1948 Warehouse Wall Remediation
951 5th Street, Macon, GA 31201
Macon Water Authority

ADDENDUM NO. A2

A. GENERAL: It is the intent of this Addendum to answer questions received after Addendum 1 up until 10am on Nov. 3rd, 2026 and to make changes to the contract documents.

WEST DEMOLITION ELEVATION – 1948 WAREHOUSE

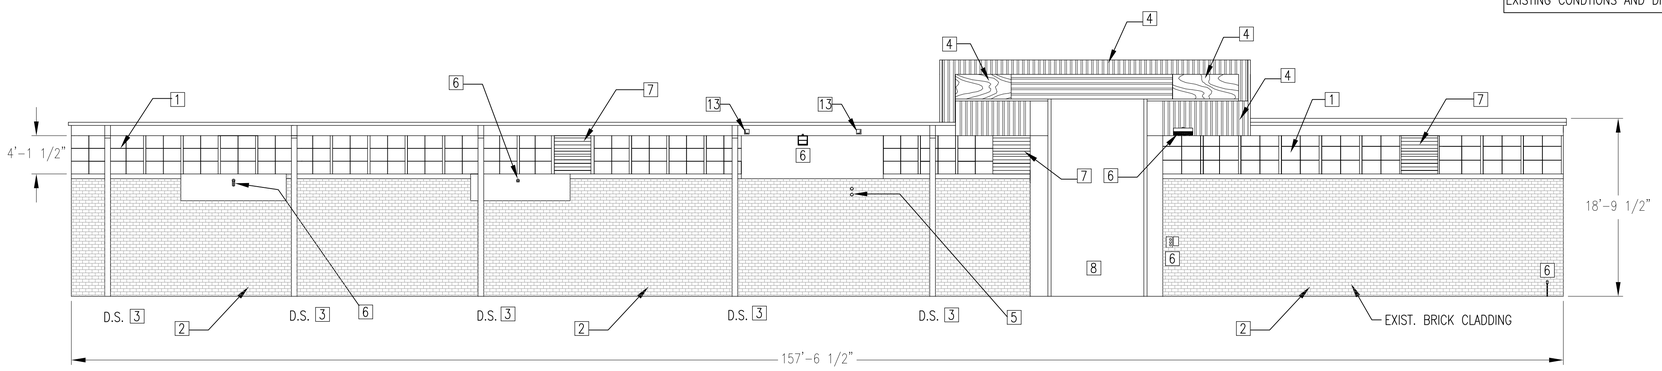
1. Section 00300-Bid: Remove and replace this section with attached "Section 00300-Bid" to add the allowance for historic masonry tuck pointing on the West Elevation.
2. Drawing Sheet A-1: Remove and replace this section with attached "Drawing Sheet A-1" to add Note #13 for West Elevation steel angle removal and add areas of CMU damage.
3. Drawing Sheet A-3: Remove and replace this section with attached "Drawing Sheet A-3" to add Note #12 for West Elevation concrete work.
4. Drawing Sheet A-5: Remove and replace this section with attached "Drawing Sheet A-5" to add tapered strip edge to Detail #1.

13. EXISTING STEEL ANGLE PROJECTING THRU OPENING IN THE EXTERIOR WALL TO BE REMOVED (TYP.).

WEST NEW WORK ELEVATION – 1948 WAREHOUSE

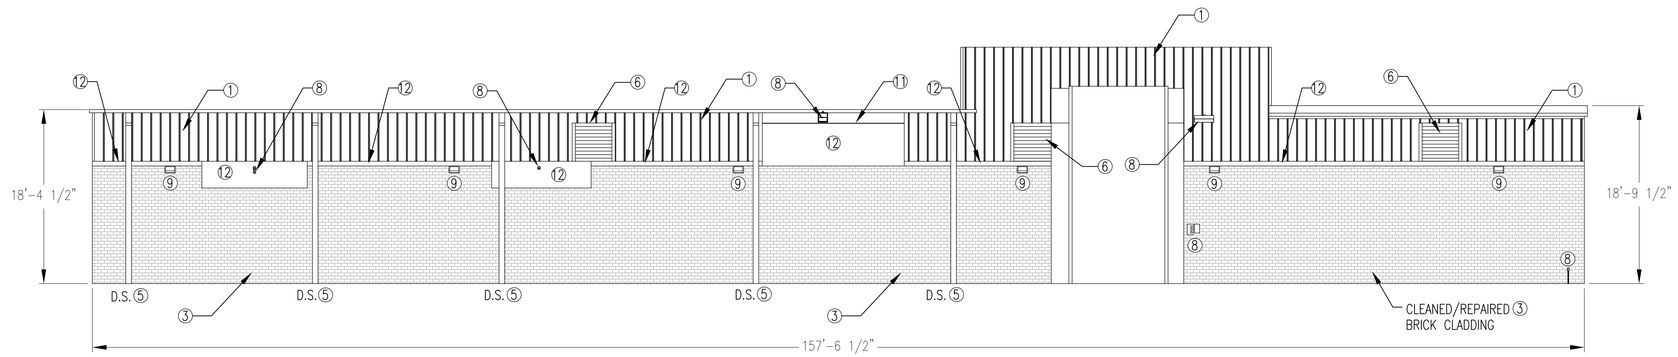
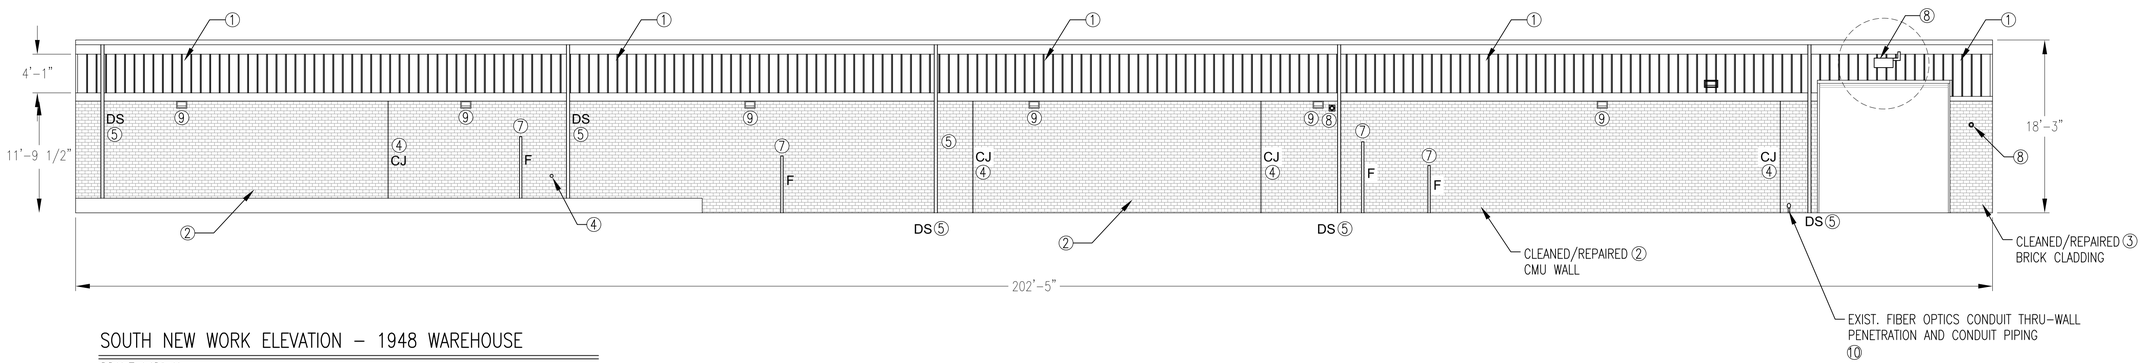
1. Change to answer for Question #3 in Addendum 1: Is there an existing circuit to tie the new exterior lighting to?

2. Can an allowance for tuck pointing be added for the west elevation?

No. In addition, the light for the West Elevation awning will have to be tied into the same new circuit as the new exterior lighting.

⑨ ALTERNATE #2: NEW LITHONIA LIGHTING TWR2 LED ALO SWW2 UVOLT PE DDBTXD TWR WALLPACKS (OR ACCEPTED EQUIVALENT) TO BE INSTALLED ALONG SOUTH AND WEST ELEVATIONS. NEW CONDUIT PIPING TO BE INSTALLED ALONG INTERIOR WALL FACE AND CONNECTED THROUGH BRICK MASONRY TO THE NEW WALLPACKS. CONDUIT PIPING TO BE ROUTED AND CONNECTED TO EXISTING ELECTRICAL PANEL W/ SPARE CAPACITY. LED WALLPACKS TO BE INSTALLED 30'–0" O.C. MAX.
